Access Compliance Report

Public Rights-of-Way

(Curb Ramps)

Intersection ID: 12436	Main Street: EASTWAY_DR	Cross Street: SANDHURST_DR	Location: W
ADA ID: 7BF03CA5344D	Ramp Type: Perp	Initial Pass/Fail: Fail	Overall Compliance: No
Severity Score: 21.25			
Codes/Mitigation Info/Possible Solution		Field Measurements/Component Compliance

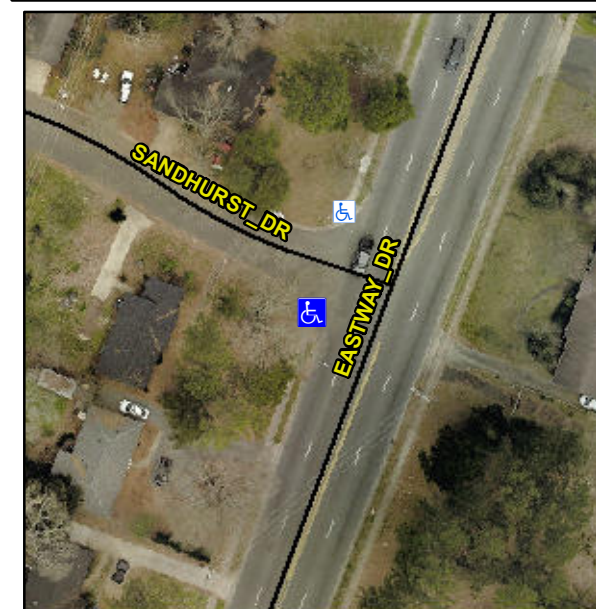
Not Found, R304.5.1, R304.5.3

Compliance	Description	Data	Compliance	Description	Data
N/A	Ramp Length (in)	31.0	Yes	Ramp Slope (%)	7.7
No	Ramp Width (in)	44.0	No	Ramp XSlope (%)	5.1
N/A	Flare Type LT	N/A	N/A	Flare Type RT	N/A
N/A	Flare Slope LT (%)	N/A	N/A	Flare Slope RT (%)	N/A
N/A	Flare Traversable LT?	N/A	N/A	Flare Traversable RT?	N/A
N/A	Landing Length (in)	N/A	N/A	DWS Provided?	N/A
N/A	Landing Width (in)	N/A	N/A	DWS Contrast?	N/A
N/A	Landing Slope (%)	N/A	N/A	DWS Length (in)	N/A
N/A	Landing X Slope (%)	N/A	N/A	DWS Full Width?	N/A
N/A	Landing Curb? (Y/N)	N/A	N/A	DWS Offset (in)	N/A
N/A	Shared Landing?	N/A			
N/A	Gutter Ponding?	N/A	N/A	Gutter Slope (%)	N/A
N/A	Gutter Lip Ht (in)	N/A	N/A	Gutter X Slope (%)	N/A
N/A	Painted X Walk1?	No	N/A	Painted X Walk2?	N/A
	X Walk 1 Direction	To NE		X Walk 2 Direction	N/A
N/A	X Walk 1 Width (in)	N/A	N/A	X Walk 2 Width (in)	N/A
	X Walk 1 Slope (%)	5.2		X Walk 2 Slope (%)	N/A
	X Walk 1 X Slope (%)	2.5		X Walk 2 X Slope (%)	N/A

Remove & Replace Entire Ramp.
